269C-1™
Handbook of Maintenance Instructions
CSP-C1-2

TEMPORARY REVISION NO. 269C1-21

SUBJECT: Reassembly, Charging and Leakage Check

This temporary revision revises step b of paragraph 5-5, Leakage Check and adds new paragraph 5-5A, Load/Stroke Inspection to Section 5, Reassembly, Charging and Leakage Check.

Figure 5-2. Landing Gear Damper Load/Stroke Inspection Apparatus

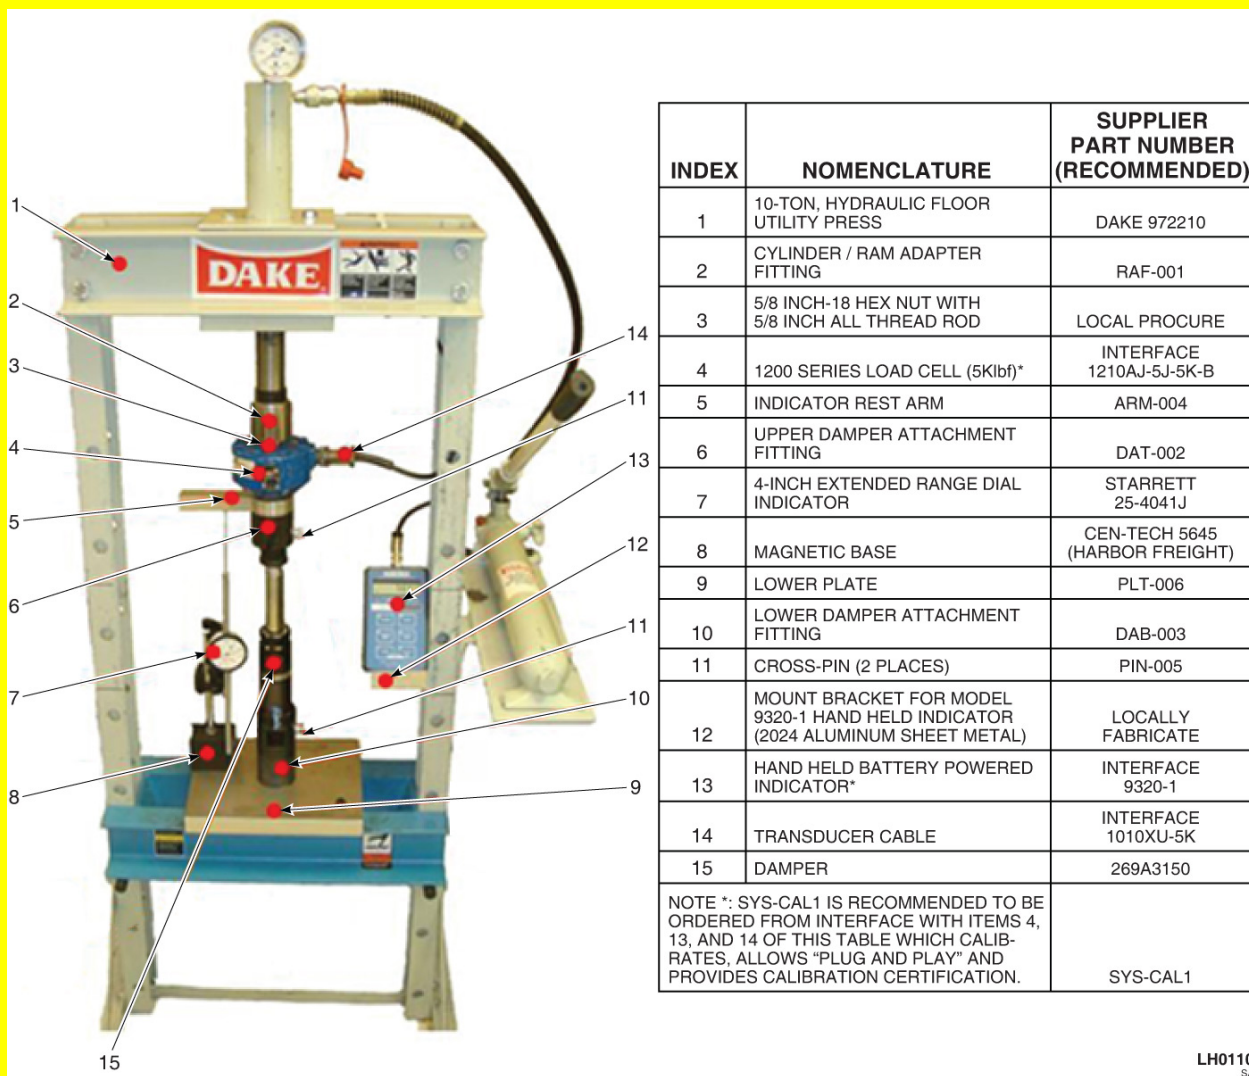
5-5A. LOAD/STROKE INSPECTION. (Figs. 5-2, 5-3, 5-4, 5-5, 5-6 and 5-7).

- b. Starting with the hydraulic press cylinder/ram retracted, pump the hand pump to position the serviced 269A3150 damper in upper and lower fittings of test apparatus. Secure damper with upper and lower cross-pins. Cross pins should turn freely with hand pressure, indicating the damper is in position and not yet under load.
- (1) Make sure dial indicator is setup to measure the range from 0.0 inch up to 4.0 inches to accurately measure the full stroke of the damper. With the cross pins able to be turned freely by hand, zero dial the indicator.
- (2) Load readings shall be monitored from the digital indicator. On the 9320-1 digital indicator, apply power to load cell by turning on the indicator by pressing the "VALLEY" button. Press the "GROSS/NET" button on the digital indicator to zero the display.

Figure 5-3. Landing Gear Damper Load/Stroke Inspection Apparatus (Upper Attachment Fitting/Load Cell Assembly)

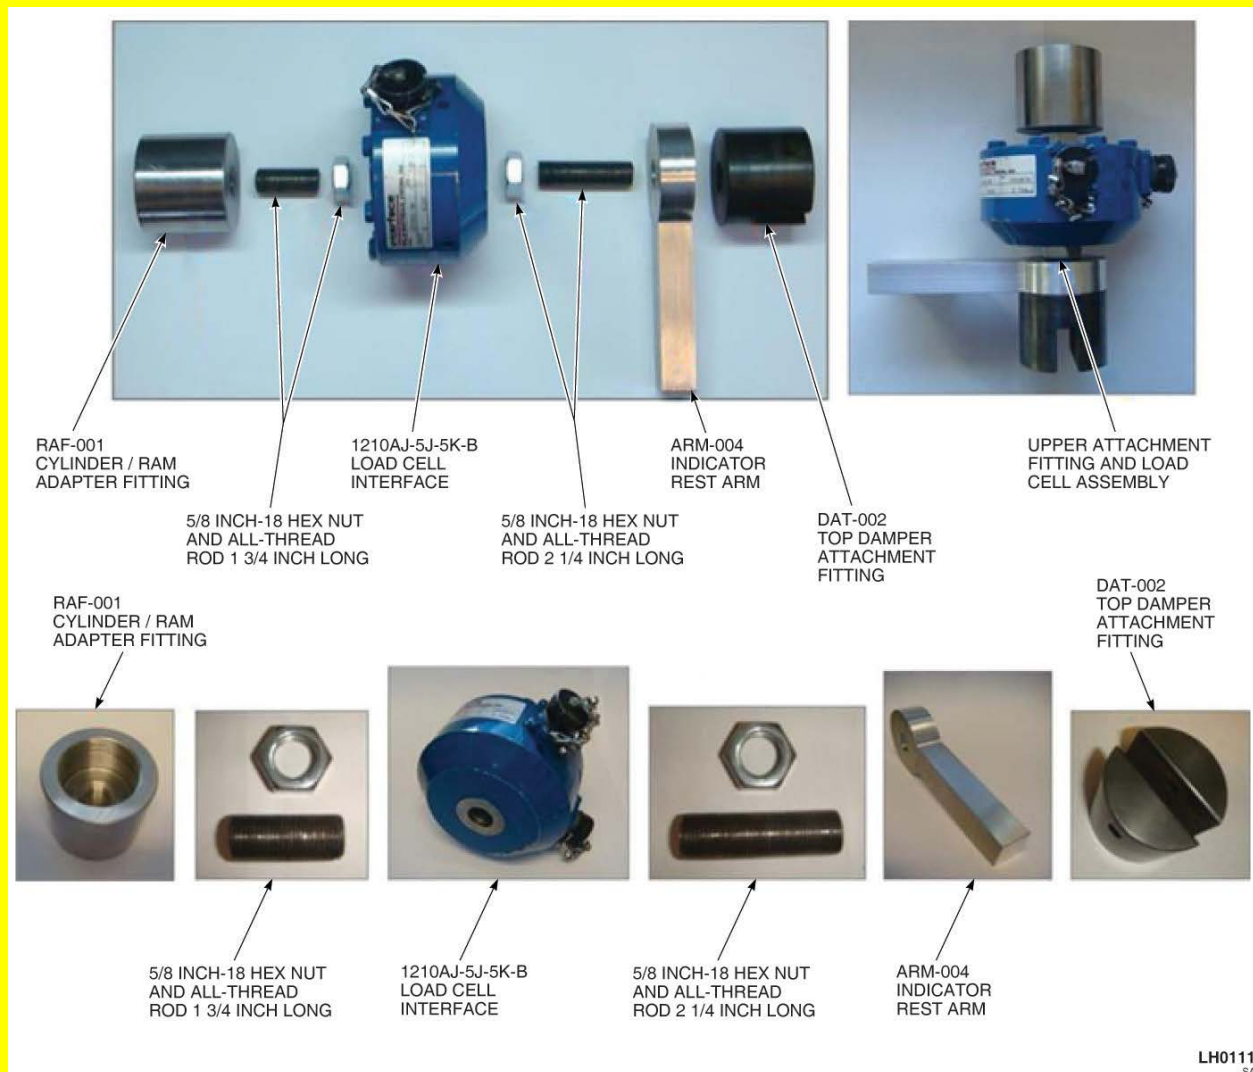
- a. Assemble load/stroke inspection apparatus using a Dake P/N 972210, 10-Ton hydraulic floor utility press, load cell, indicator and addition equipment or equivalent as follows:
 - (1) Locally fabricate parts in accordance with Figure 5-7.
 - (2) Assemble parts as shown in Figure 5-3, threading 5/8 inch -18 all-thread and nuts together.
 - (3) Make sure load cell connectors, top damper attachment fitting, and indicator rest arm are positioned as shown in Figure 5-3.
 - (4) Torque nuts and fittings to 50-70 in.-lbs.
 - (5) Remove hydraulic press cylinder ram cap.
 - (6) Install upper attachment fitting/load cell assembly to hydraulic press (Figure 5-6).
 - (7) Thread 5/8 inch -18 all-thread into bottom damper attachment fitting (Figure 5-4).

Figure 5-5. Landing Gear Damper Load/Stroke Inspection Apparatus (Load Indicator Bracket Mount)

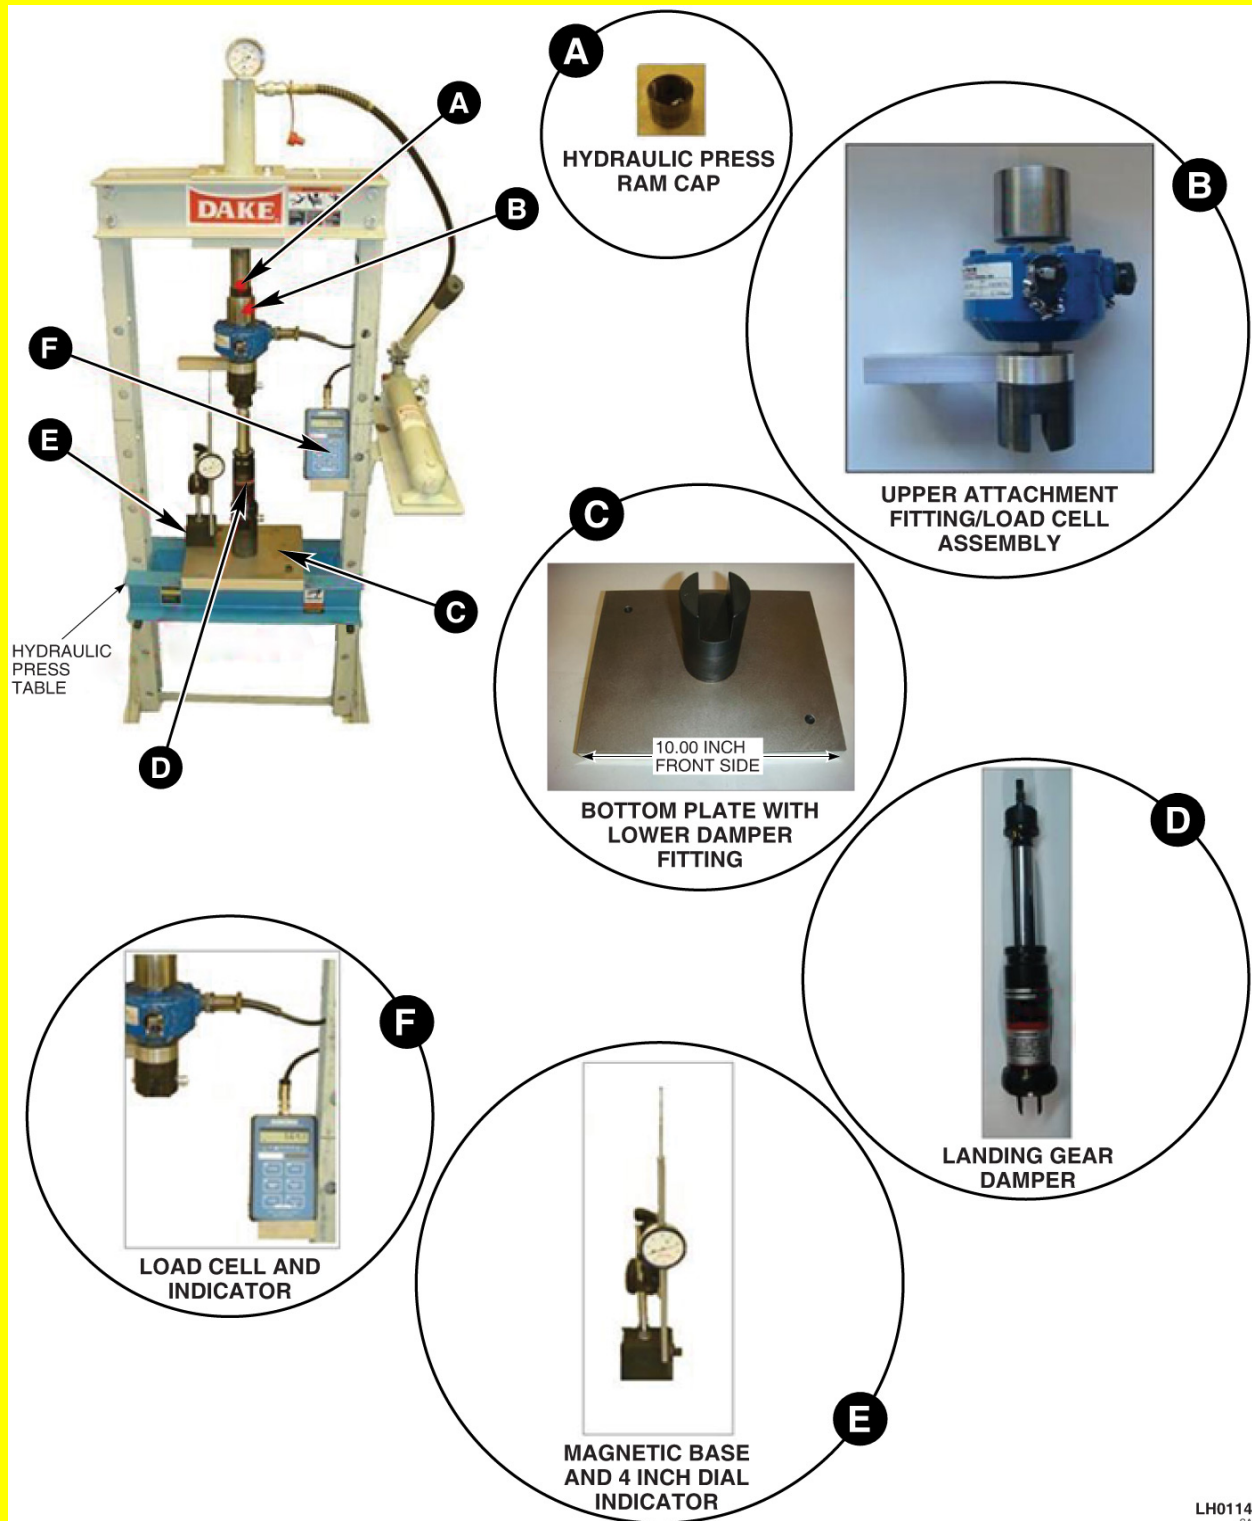
- (10) Install lower plate with damper attachment fitting as shown in Figure 5-6.
- (11) Locally fabricate bracket from 2024-T3 aluminum (size to fit Model 9320 indicator is 3.5 inches x 6.0 inches x 1.3 inches, and weighs 0.5 pound) or equivalent. Mount bracket to hydraulic press as shown in Figure 5-5, or equivalent location, using suitable hardware.

- (b) Verify cross-pins turn with light hand pressure to make sure damper is not under load.
 - (c) Zero dial indicator.
- (16) Secure load indicator to bracket (Figure 5-5).
